Model: Bellini LCT	Date: 25-Apr-00	No.: MB303001
--------------------	-----------------	---------------

Modified Article: Noise Absorber Seal		Prepared by: H.K.	
From: Technical Services Dept., GTS Division			
Reason for Modification:	<input type="checkbox"/> Parts catalog correction	<input type="checkbox"/> Vendor change	<input type="checkbox"/> To meet standards ()
	<input type="checkbox"/> To facilitate assembly	<input type="checkbox"/> To improve reliability	
	<input type="checkbox"/> Part standardization	<input checked="" type="checkbox"/> Other

Model: Bellini LCT		Date: 29-May-00	No.: MB303002
Modified Article: Felt Wick Spacer & Flange		Prepared by: H.K.	
From: Technical Services Dept., GTS Division			
Reason for Modification:	<input type="checkbox"/> Parts catalog correction	<input type="checkbox"/> Vendor change	<input type="checkbox"/> To meet standards ()
	<input type="checkbox"/> To facilitate assembly	<input type="checkbox"/> To improve reliability	
	<input type="checkbox"/> Part standardization	<input checked="" type="checkbox"/> Other

Noise Absorber Seal

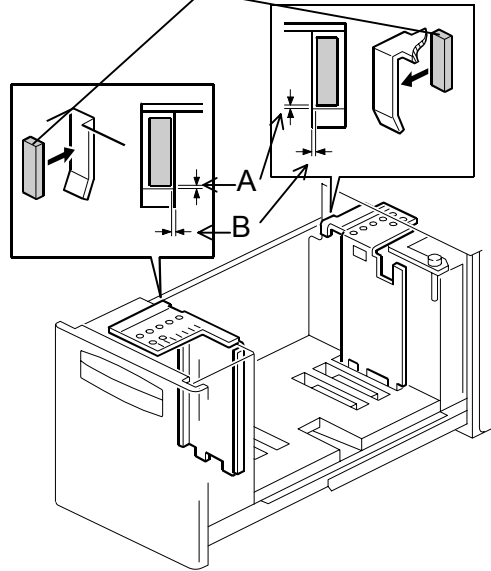
To minimize the feeding noise from the LCT, a noise absorber seal has been stuck on the reverse side of each side fence (three feed trays, front and rear: total 6 pcs).

A: 0 ~ 0.5

B: 0 ~ 0.5

Diagram No.1

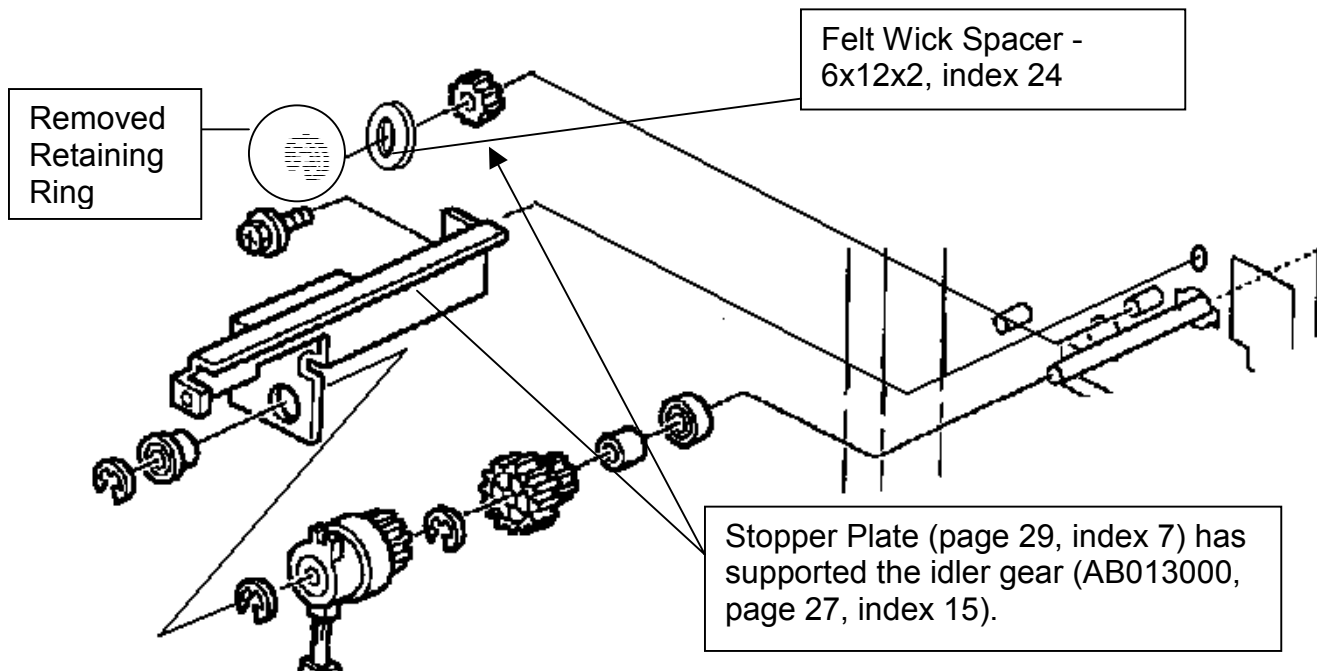
When the LCT was connected to the 105 cpm machine in a laboratory test, noise was generated from the thrust gap between the relay clutch and idle gear because of the higher paper feed speed. To correct this, a felt wick spacer has been added and one retaining ring has been removed. The idler gear (AB013000) is now supported by the stopper plate instead of the removed retaining ring.

Diagram No.2

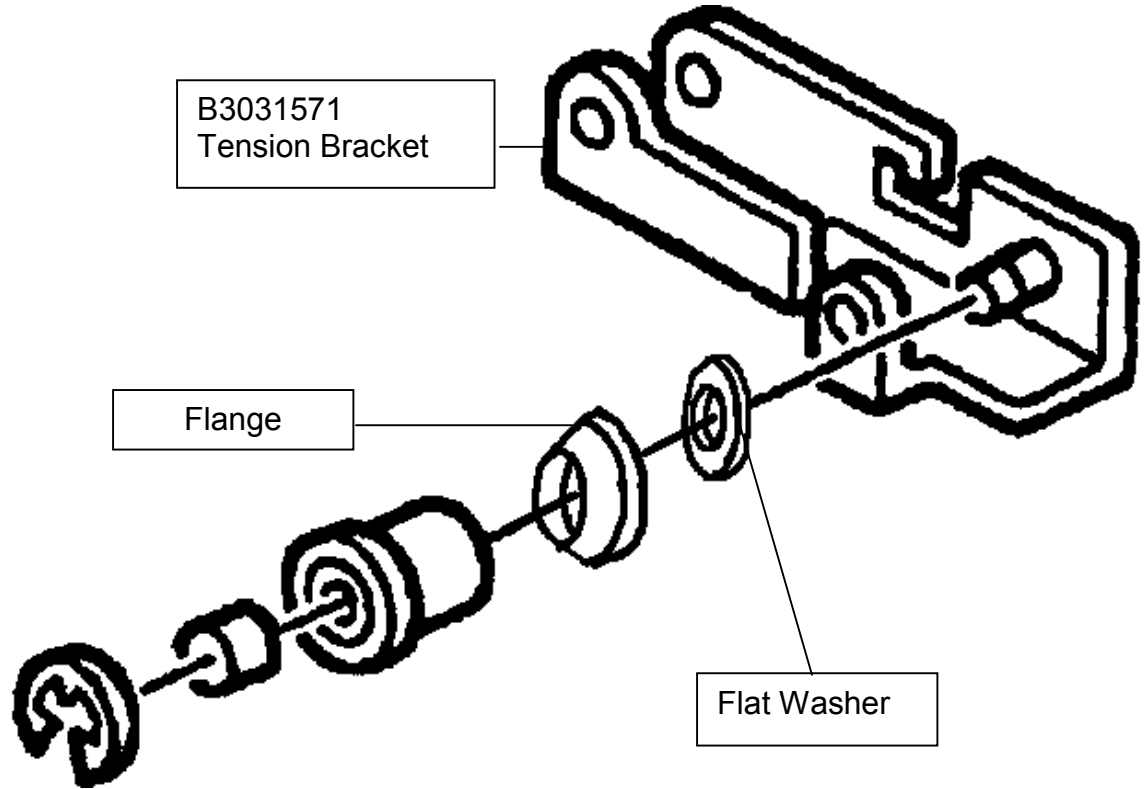
When the LCT was connected to the 105 cpm machine in a laboratory test, the timing belts tended to slip off the idler pulley. To correct this, a flange and a flat washer have been added to each tension bracket (B3031571, page 27, index 14 and page 29, index 15).

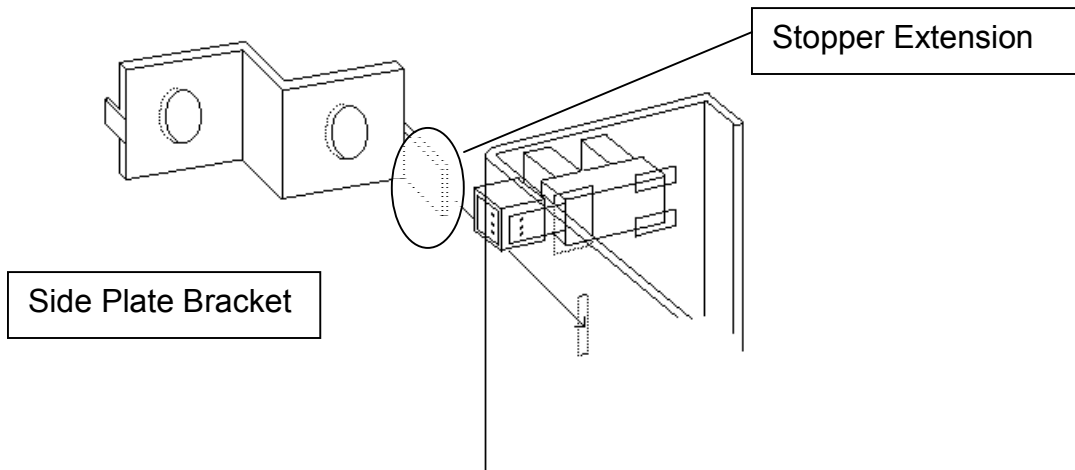
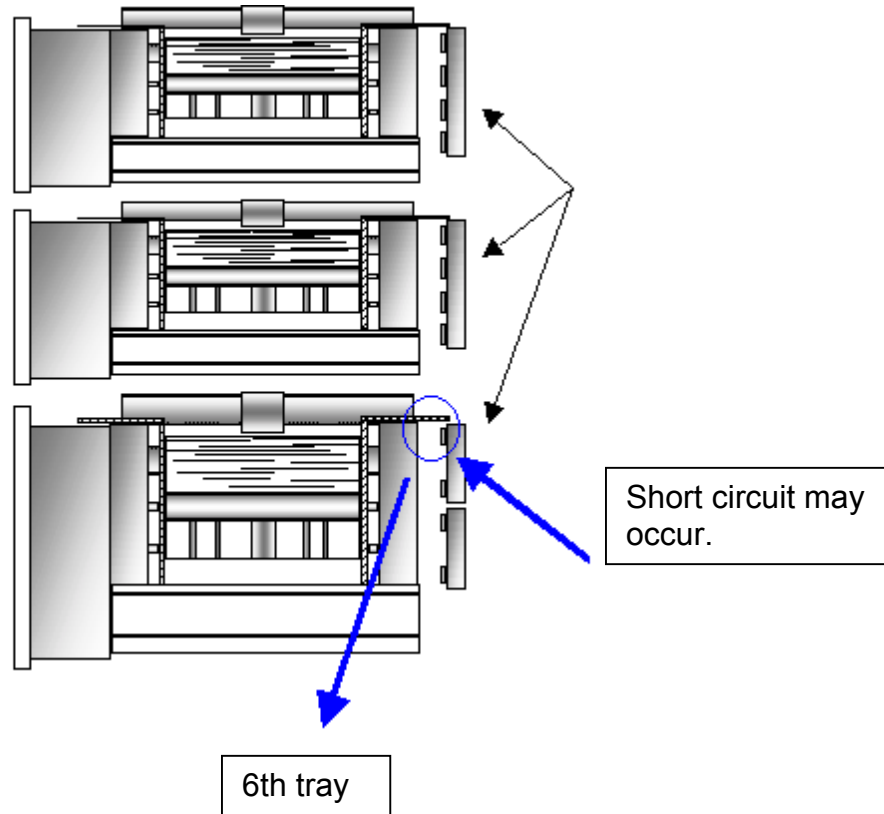
If Tray 6 (2550-sheet tray) with a large amount of paper is forcibly pushed into the LCT main body, the rear LCT side plate may be temporarily bent. This may cause the side plate bracket to touch the paper height sensors, which can sometimes result in a short circuit or damage to the sensors. To correct this, a stopper extension has been added to the side plate bracket. Therefore, even if the above situation occurs, the side plate bracket is stopped by the stopper extension. This will ensure that the bracket does not touch the sensors.

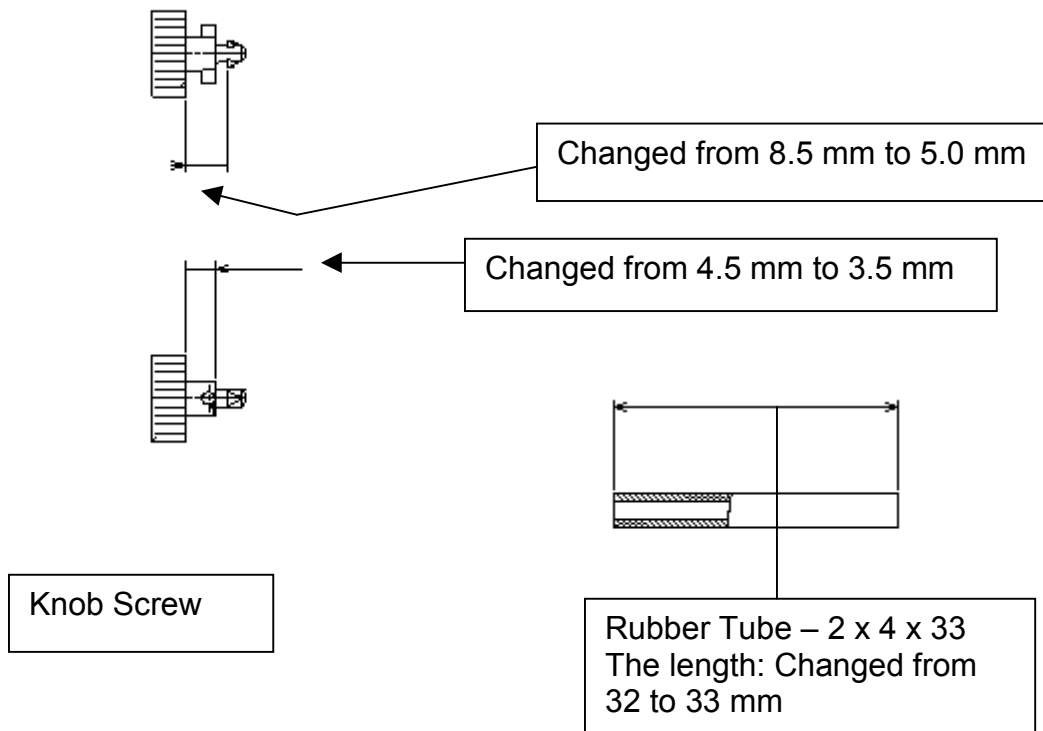
When changing the paper size, operators have to change the position of the end fence (Knob Screw with Rubber Tube). When the operator installs the end fence in the hole in the paper guide fence incorrectly, the top of the end fence is higher than normal. The end fence may tend to be broken by the tray front cover when the tray is pulled out. To improve the durability of the end fence, the production machines have been modified as follows:

1. The knob screw has been made shorter.
2. The rubber tube has been made 1 mm longer.

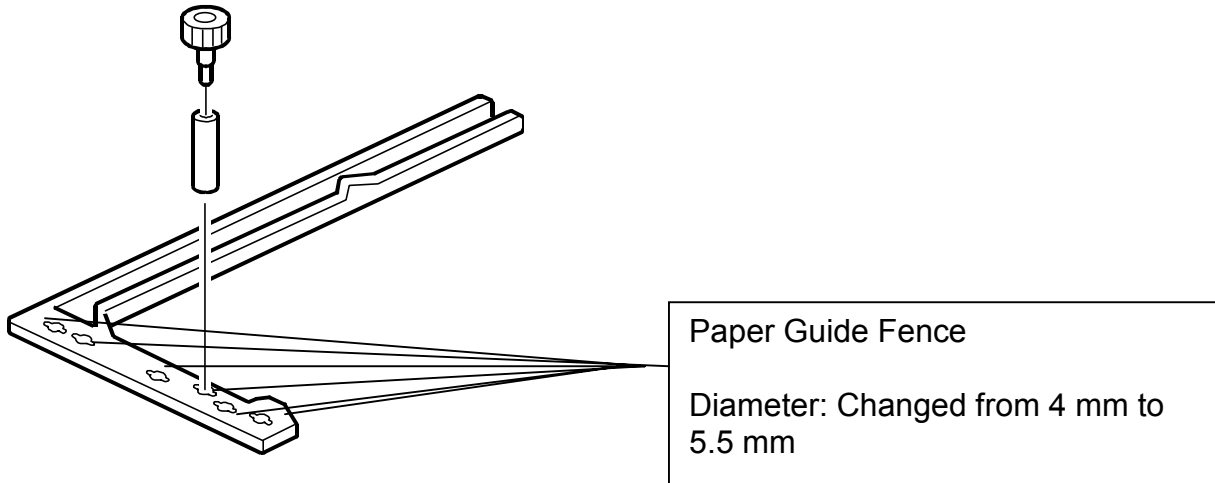
- The diameter of the holes for inserting the end fence (Knob Screw with Rubber Tube) in the Paper Guide Fence has been changed from 4 mm to 5.5 mm.

Note: When replacing any of the old parts in the field, install all three new parts as a set.

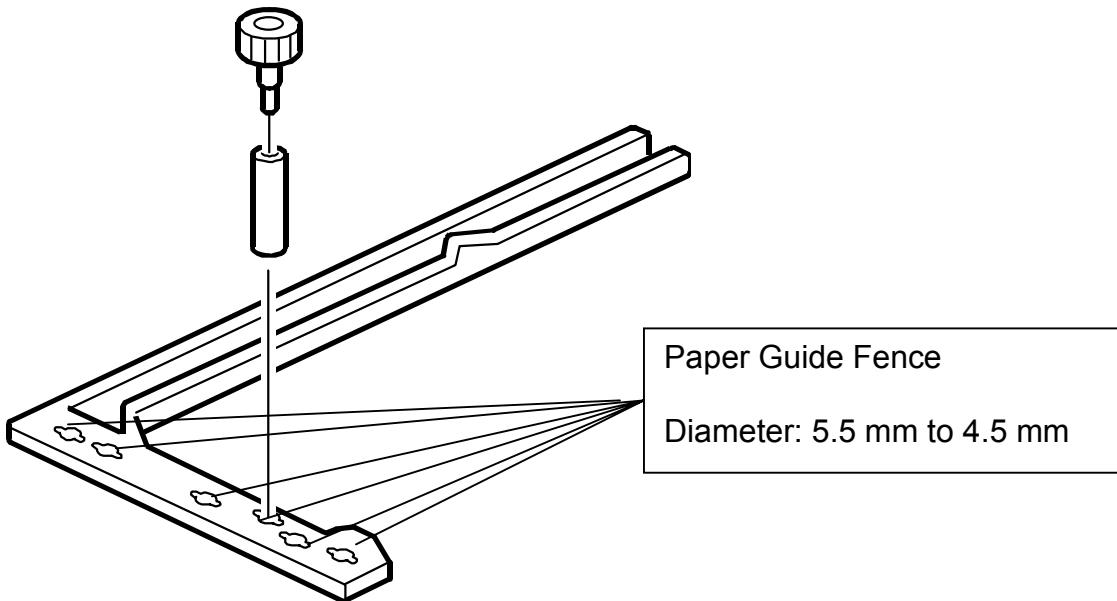
The end fence may drop due to vibration during transportation. The diameter of the holes in the paper guide fence for inserting the end fence (Knob Screw with Rubber tube) has been changed from 5.5 mm to 4.5 mm.

The part modification history of the paper guide fence is as follows:

- B3032781 (4 mm diameter)
- ↓: X/X: Refer to MB No.04.
- B3032786 (5.5 mm diameter)
- ↓: X/O
- B3032789 (4.5 mm diameter)

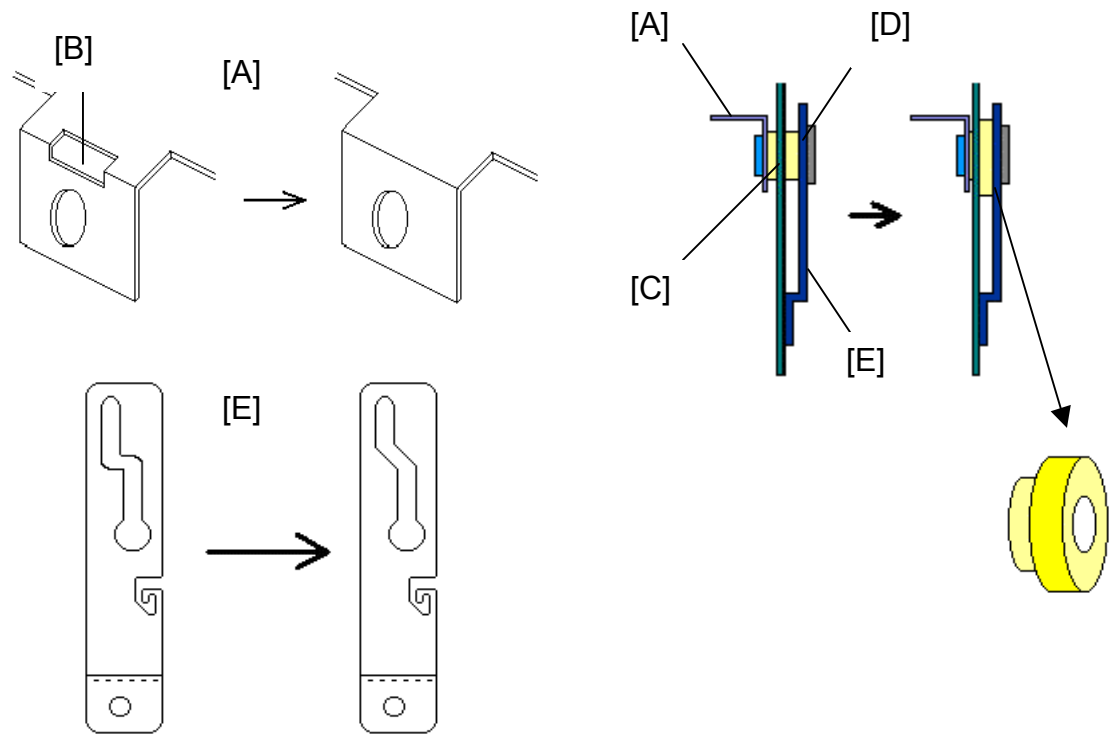
To improve the durability of the LCT guide plate open/close mechanism (for U3 jam removal), the following modifications have been applied:

1. The length of the guide plate [A] (B3033645) has been increased by 1 mm to remove the play between the guide plate and the frame. Also, cutout [B] has been removed to strengthen the plate.
2. Collar [C] and stepped screw [D] have been changed to remove the space between the frame and the linkage bracket [E].
3. The shape of the linkage bracket [E] has been changed to ensure smoother movement of the guide plate. Along with this modification, the tension of the tighten spring (AA060830) has been increased.

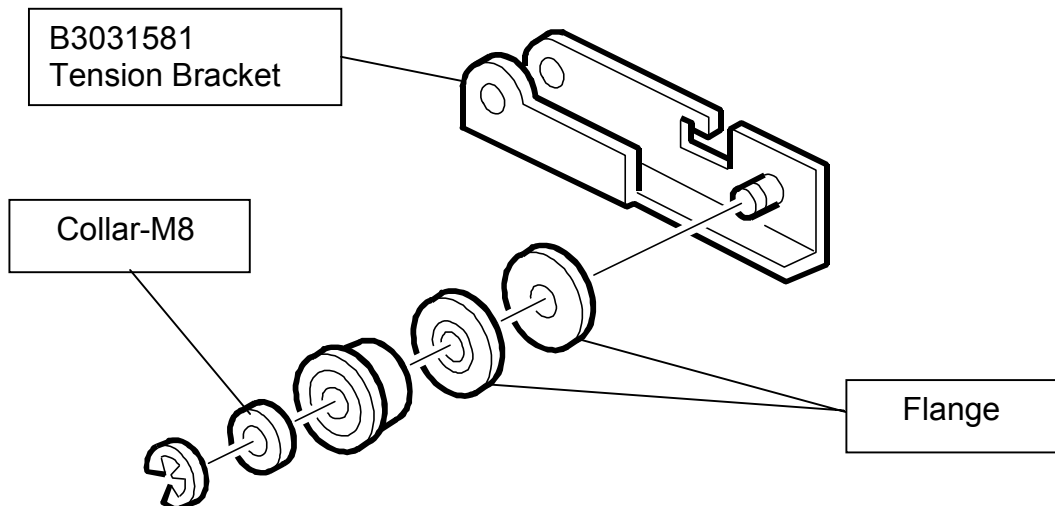
The tension bracket can sometimes contact the flat washer when the LCT is used, generating noise. To correct this:

1. The flat washer has been changed to a flange, so that two flanges are now used.
2. The bushing has been changed to a collar.
3. The shape of the tension bracket has been modified.

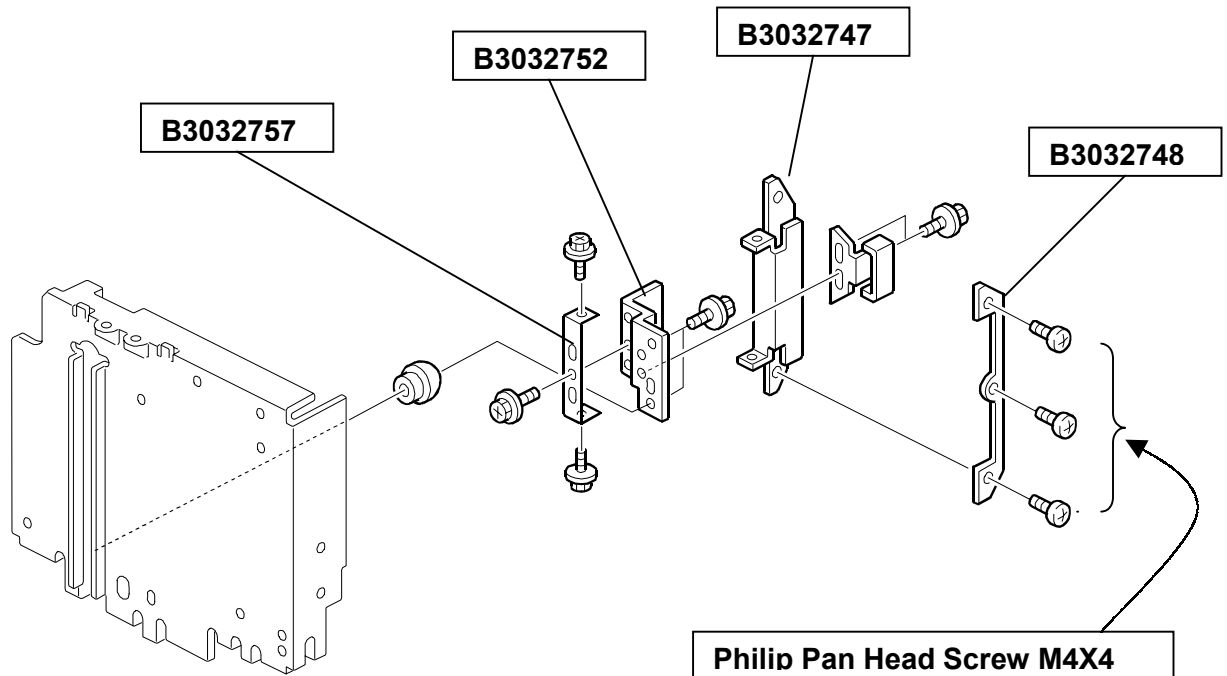
To prevent the spring plate from being broken, an actuator cover (B3032748) has been added to the paper actuator (B3032747).

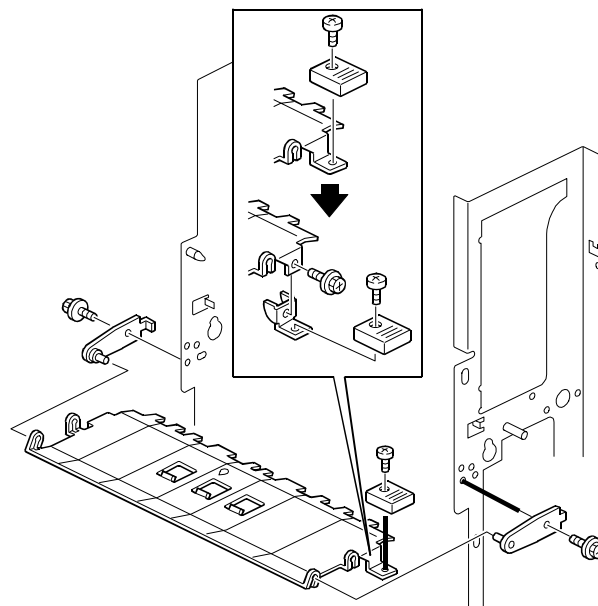
Sometimes slack develops in the B3033698 guide plate, which can then contact the transport roller and wear down its surface. To ensure that this does not occur:

1. The shape of the B3033698 guide plate has been changed.
2. The shape of the B3033635 guide plate has also been changed. In addition, the lever which was previously part of this plate has been attached as an individual part, strengthening this area. A tapping screw has been added for attachment.

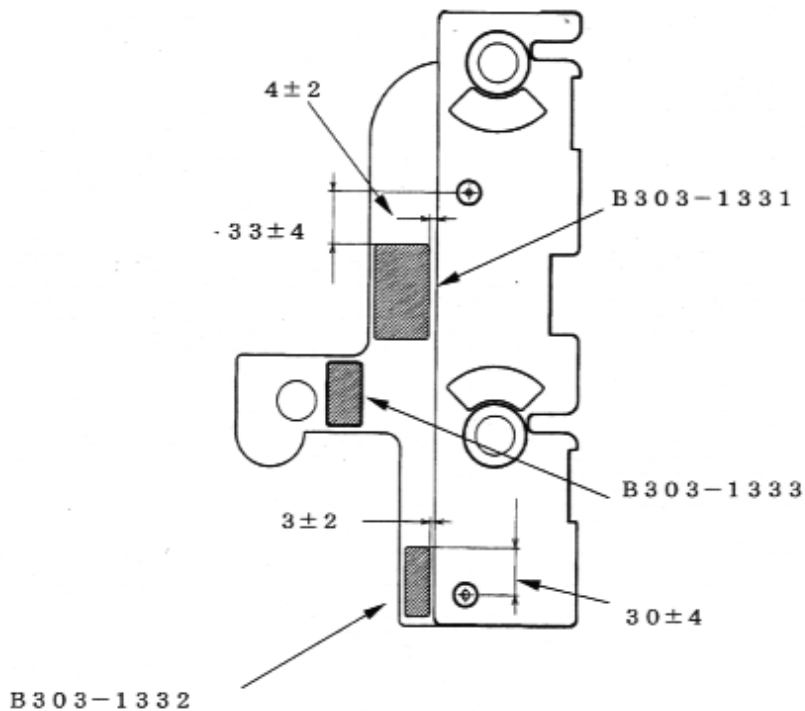
To make sure that customers turn the jam removal levers in the correct direction, the following decals have been added.
